HUMEFILTER INDEPENDENT EVALUATORS REPORT

SQIDEP HumeFilter

Date 10 July 2023

Description Independent Evaluators Report issued to Stormwater Australia

Figure 4. Site rainfall data

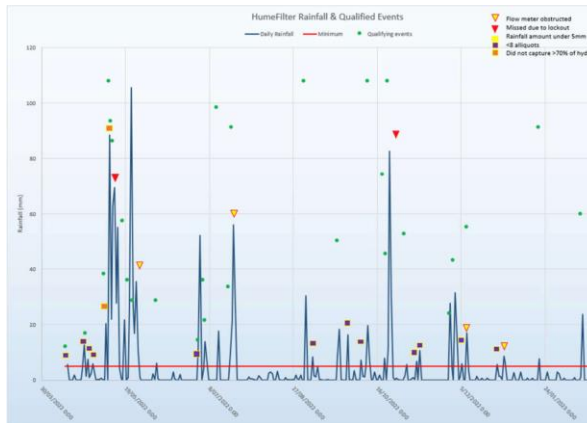
Rainfall data was collected at the site in a pluviometer for nearly a year. This was presented as a graph in Appendix A of the DPR report. The same period of record was obtained from the Sunshine Coast Airport (station 040861) as graphed independently. The comparison is shown below in Figure 4 and Figure 5. There are notable differences in the rainfall data however these are readily explained by the fact that the BOM data is accumulated into daily data as well as being in a different location. Given these facts the rainfall data appears to correlate quite well and there is a high level of confidence in the site records.

Figure 4 above provides a good graphic of the non-qualifying events (with explanation) that strongly suggests that there is no cherry picking of storm events.
